## ORIGINATION FORM

Index Number: 455-440

Index Title: Precast Concrete Sheet Pile Wall (CFRP/GFRP & HSSS/GFRP)

Changed Prestressing Strand SS Note

NOTES AND DETAILS

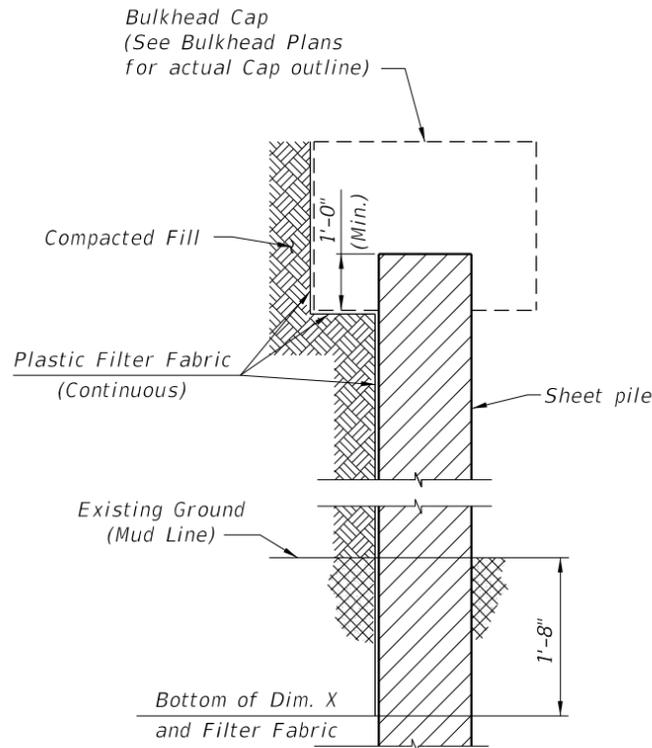
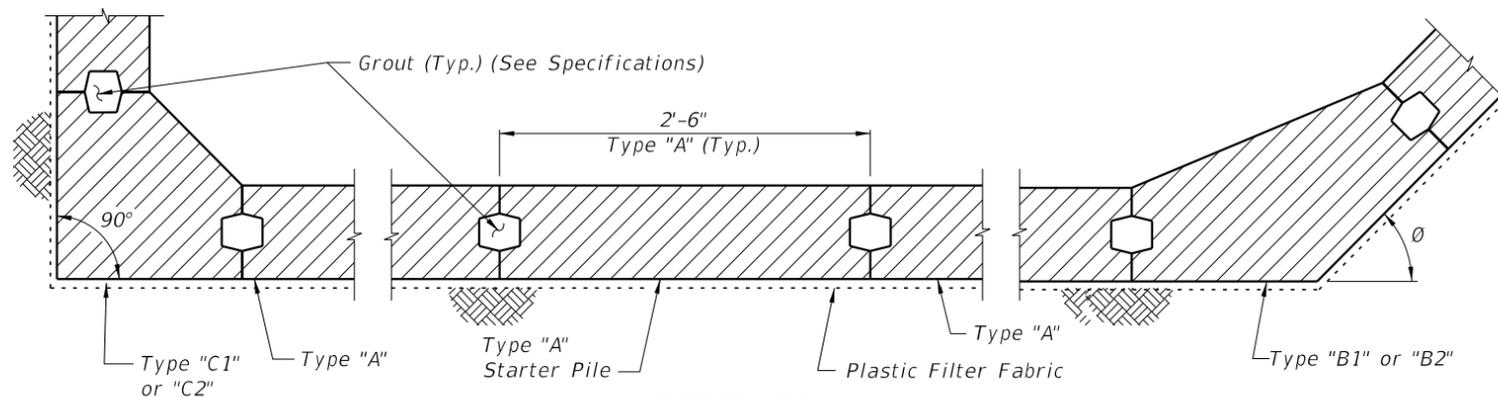
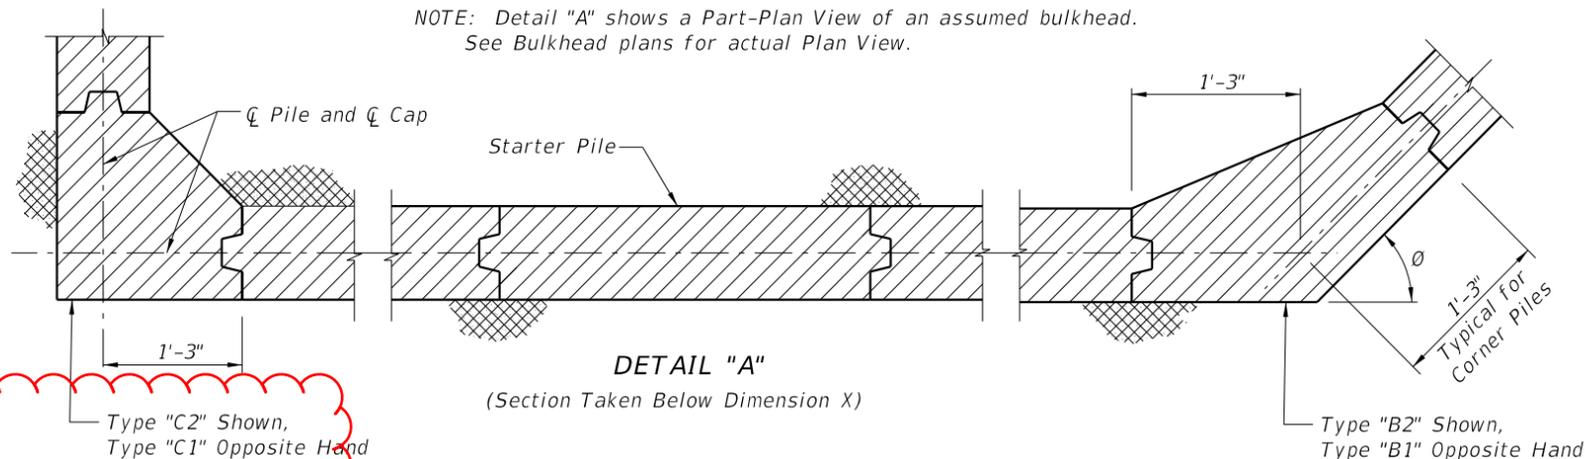
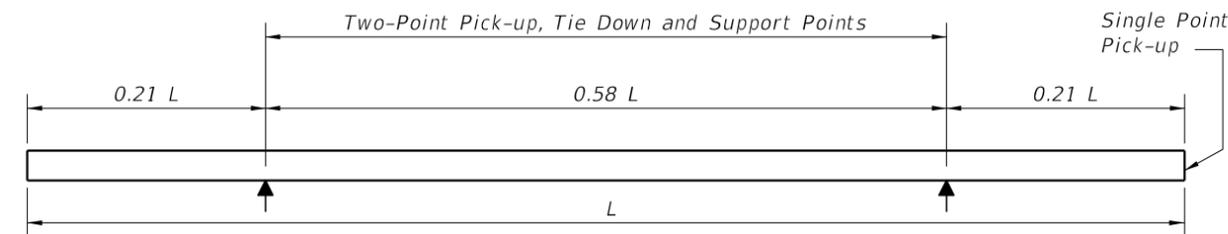
New criteria for HSSS strand

Stainless Steel: Prestressing steel shall be seven-wire HSSS, ~~UNS S32205 (Type 2205)~~ or ~~UNS S31803~~ strand, meeting the requirements of Specification Section 933.  
 Carbon FRP: Prestressing strand shall be CFRP strand, meeting the requirements of Specification Section 933.

Stainless Steel: Prestressing steel shall be seven-wire HSSS, Grade 240 strand, meeting the requirements of Specification Section 933.  
 Carbon FRP: Prestressing strand shall be CFRP strand, meeting the requirements of Specification Section 933.
